## Appendix C - Public Comments Received from Open House

## East Side Lands – Stage 2 Master Environmental Servicing Plan (MESP) Secondary Plan Study Re-initiation. Public Open House.

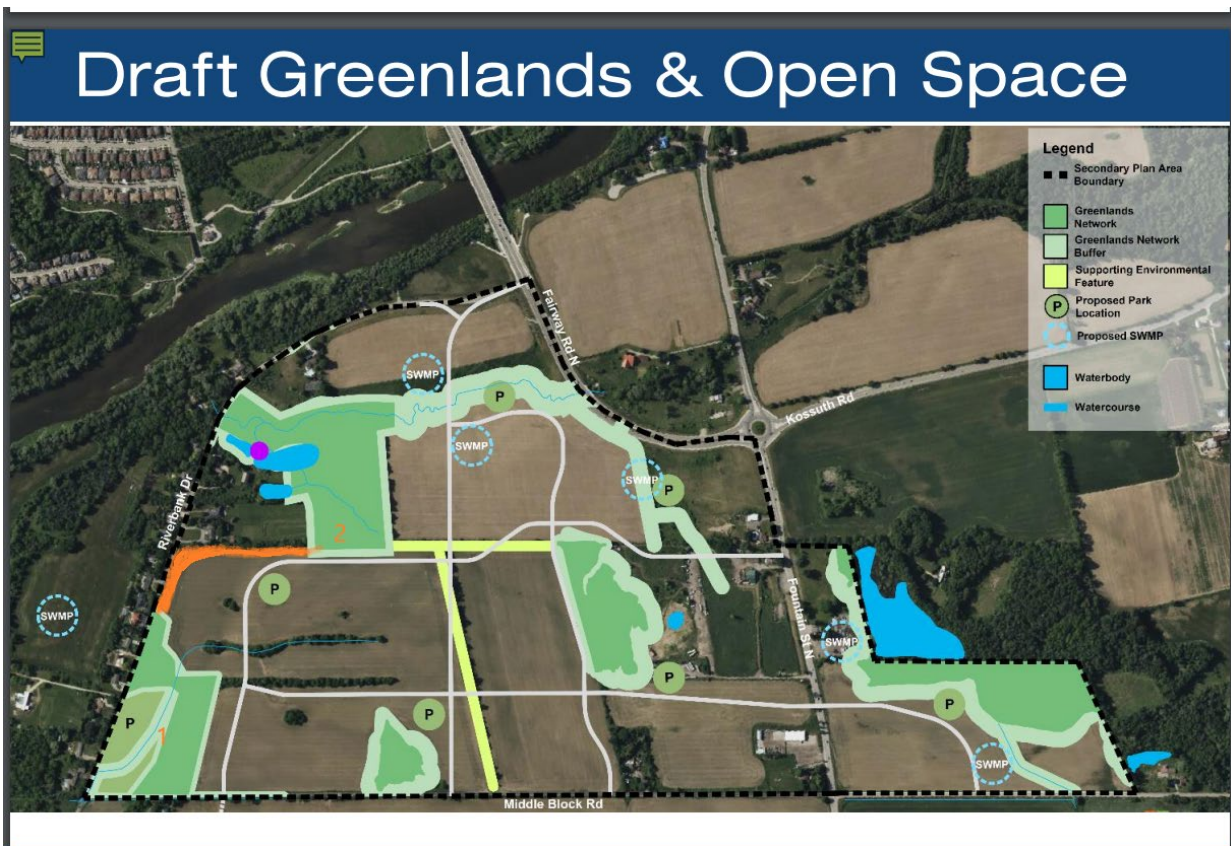
Although the intersection of Middleblock Rd and Riverbank Drive is an already established feature of the road system, this was established at a time when there was no thought to a large development road system.

This access to Riverbank Drive has the potential to encourage traffic to avoid a busy collector road at any sign of congestion and use Riverbank Drive to travel south to King Street.

It appears to me that the access to Riverbank Drive here is traditional rather than planned and that if there had been no access before, this plan would not consider a spur between the roundabout and Riverbank Drive.

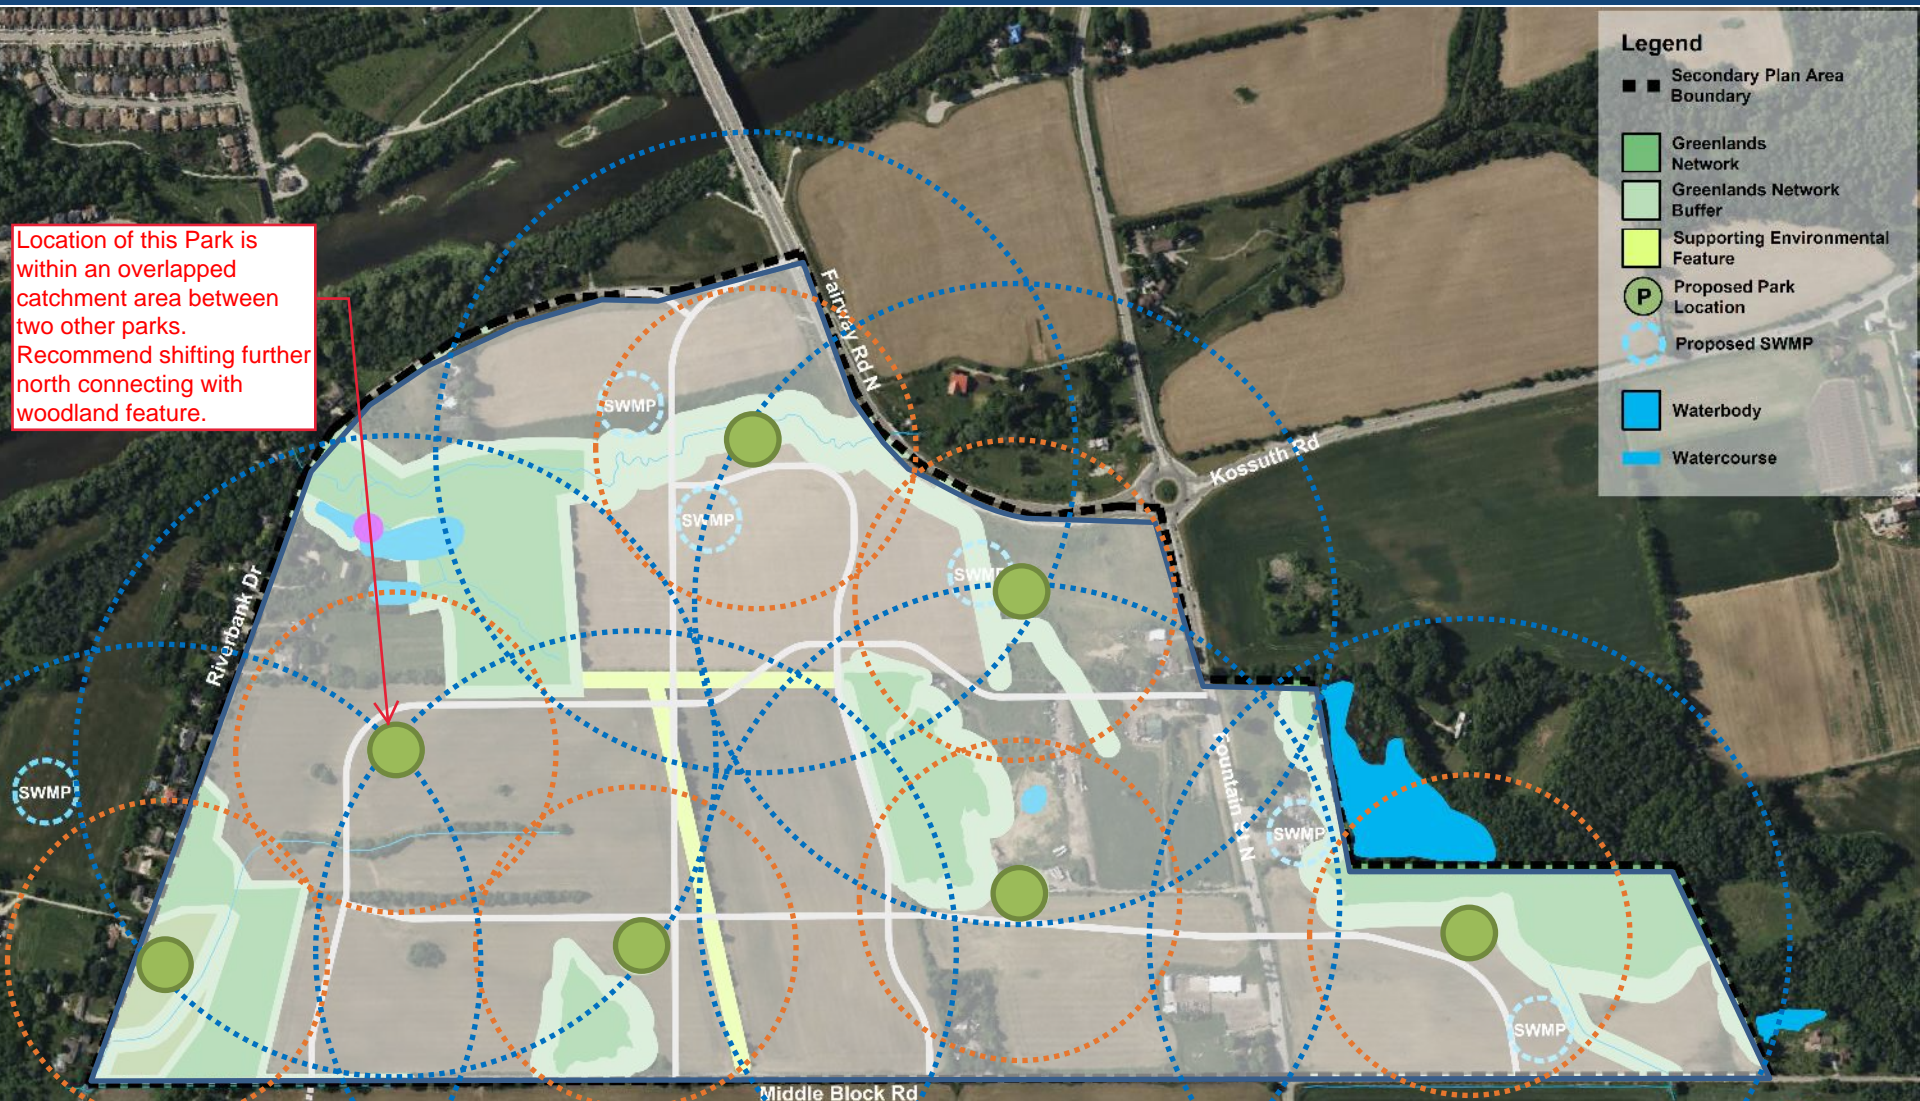
It appears the proposed park location south of the woodlot (see mark up) is located in an area that is within 400m of two other proposed parks. Within the Madison lands, the two proposed parks would be located within 400m of all future residential areas. Given the overlap of coverage, we believe the location of the park in question should be placed further north to better serve the lands north of the Madison lands.
